Garden City Design Review Application Review

SAPFY2023-0001

SAP at River Club

Review Date: 2-2023
Applicant Meeting Date: 2-6-23, 2-21-23

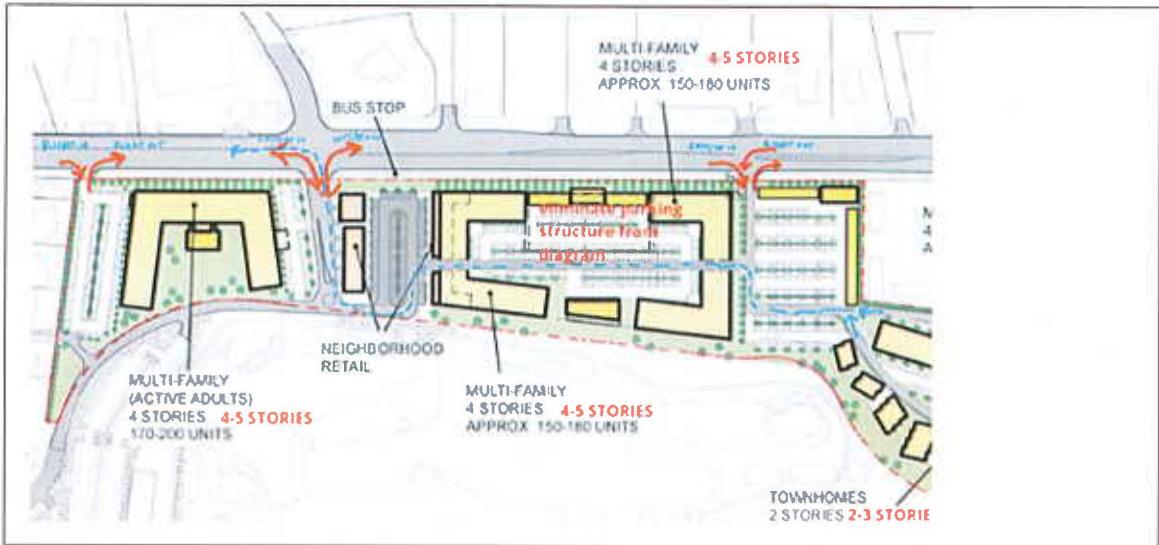
- b. Increase useability and intuitive function of traffic flow from East Sub through Center Sub travelling west to access signalized intersection.

Agreed. The useability and function of traffic flow throughout the project, especially from the central and east subdistrict to the signalized intersection at Pierce Park Lane, will be ensured with the use of, e.g., wayfinding signage, patterned paving materials, and landscape.

The drawing below provides an example.

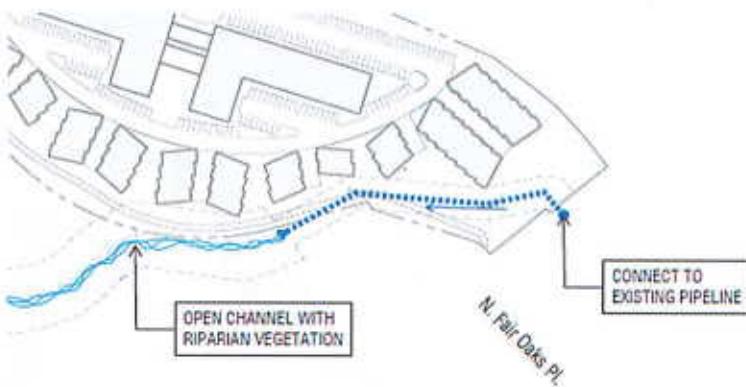
7. Recommend newly developed area “SHALL” be connected to pressurized irrigation of nearby surface irrigation water as required by Idaho Code rather than “MAY”.

- a. Supports Comp. Plan Goal 4 & 9.

Agreed that newly developed area shall be connected to pressurized irrigation. We do not see where the word “may” was used. Please point us in the right direction out so we can appropriately revise the language.

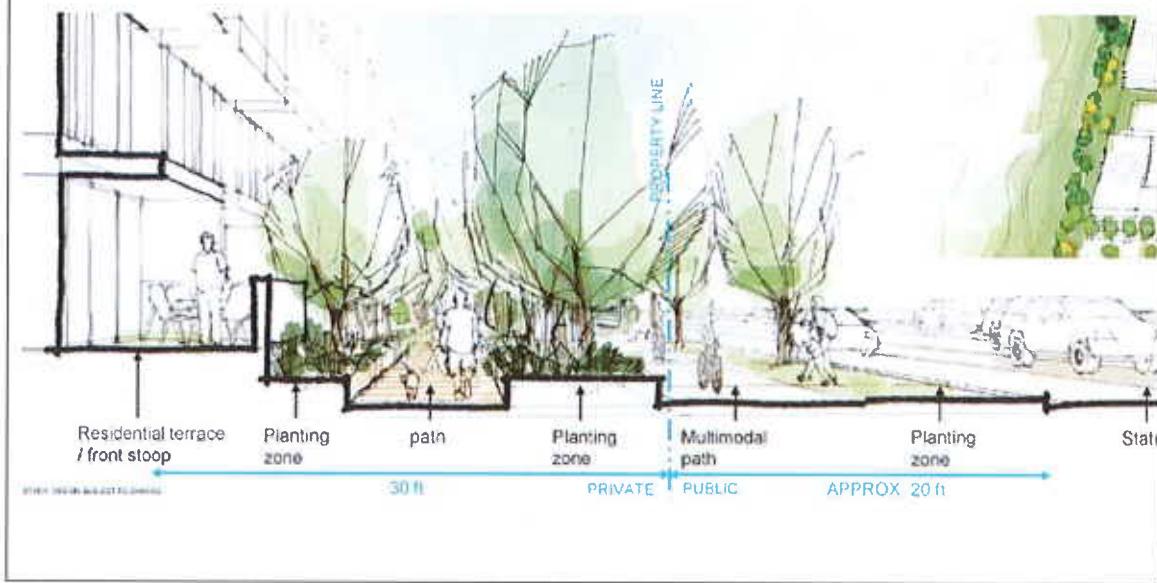
- c. Recommend maintaining 4' barrier between common open space and adjacent collector and arterial streets unless a 2' high barrier and additional landscape buffer (with defined minimum depth that will allow incorporation of trees, shrubs and boulders) is provided.

We believe that this comment is an agreement to our approach. We appreciate that a constructed barrier provides protection from major street traffic, which is why the Applicant's landscape architect insisted on additional landscape, including boulders, should the constructed barrier be lower than 4'. The concern is that 4' is relatively high and can produce a tunnel effect.

The drawing below shows the rendering we shared with neighbors. Any constructed wall would be located at the line separating private from public space. An absolutely-required 4' wall at such a location may not be appropriate.
